UNITED STATES  
NUCLEAR REGULATORY COMMISSION

SUBJECT: TECHNICAL ASSISTANCE REQUEST - II-VI INCORPORATED

**TECHNICAL ASSISTANCE REQUEST  
II-VI INCORPORATED  
REVIEW OF RESRAD ANALYSIS**

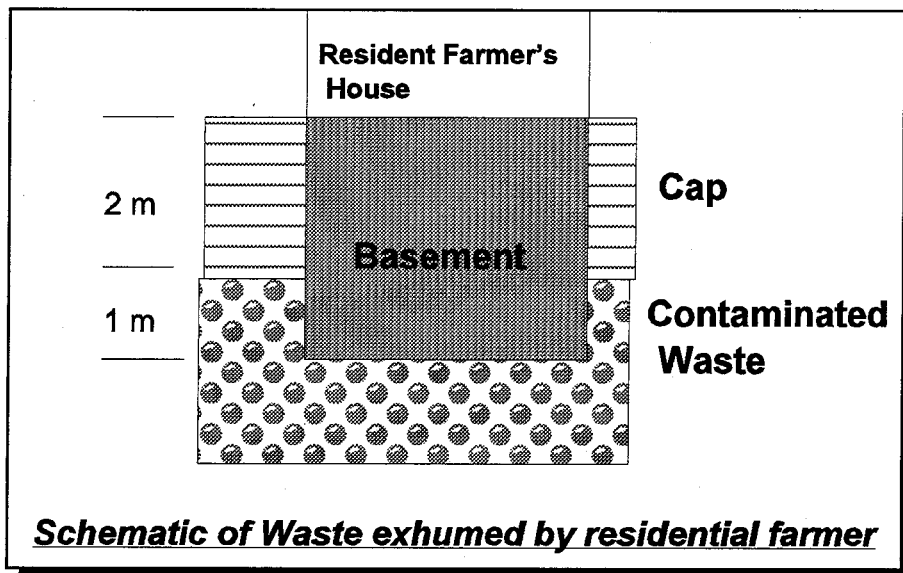
In the residential farmer scenario it is assumed that someone resides in a house atop the contaminated area and consumes food grown on the site. It is also assumed that the hypothetical future resident farmer will excavate a volume of 600 m<sup>3</sup> in building a foundation for their house. The top 2 meters of this excavated volume are assumed to be cover material, while the bottom 1 meter would be disposed waste (see below).

Of the 600 m<sup>3</sup> exhumed in the scenario, the disposed waste accounts for only 200 m<sup>3</sup>. However, the scenario assumes that this material, which would otherwise be "shielded" by a 2 m cap, is then distributed over a large area at the surface. This results in a member of the critical group receiving significant exposure to the waste through plant and animal uptake, soil ingestion, and external gamma radiation (significant for Th-232). Note that all of these pathways would be negligible if the material remained shielded and at depth.

While II-VI stated they used the resident farmer scenario for their analysis, they did not include in their model the exhumation of any contaminated material.

**Total Dose (max. 151 mrem/yr)**

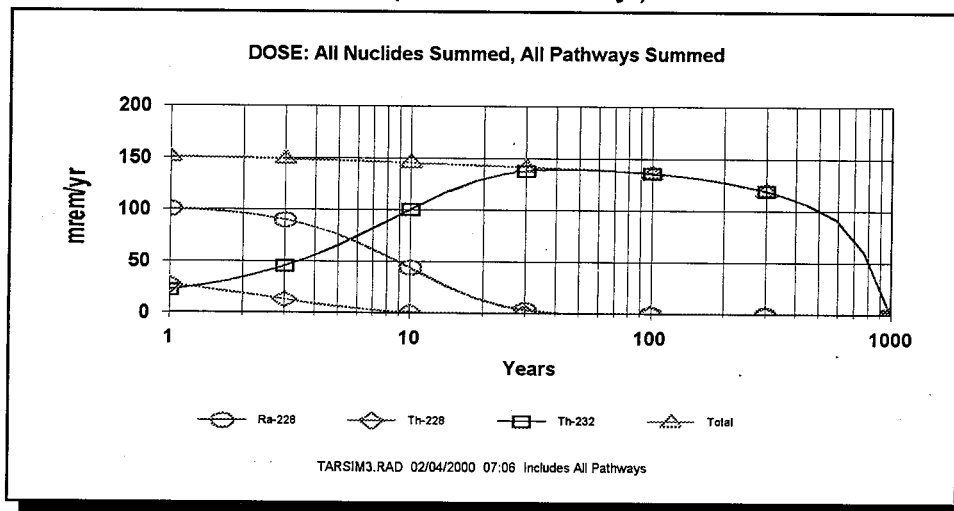
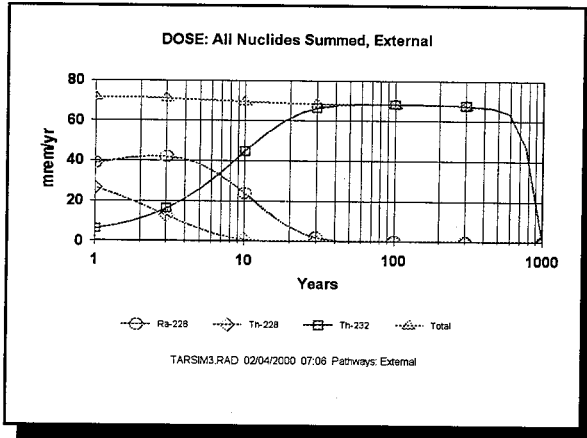
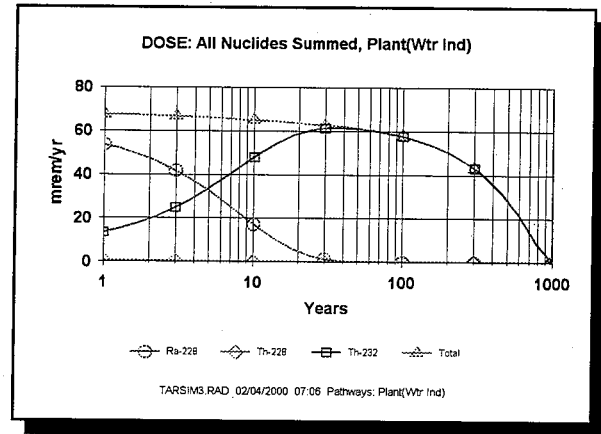
The three graphs below display the dose from Simulation 1, which essentially accounts for the entire dose. As the above table and the below figures demonstrate, the external and plant (water independent) pathways, account for the overwhelming majority of the dose.

The contrast from staff's Simulation 1 and the low dose achieved in II-VI's model can be accounted for by II-VI's lack of consideration of exhumed radioactive material. The overwhelming majority of the dose came from Scenario I, which placed contaminated material at the surface; a significant aspect of the resident farmer scenario omitted by II-VI.
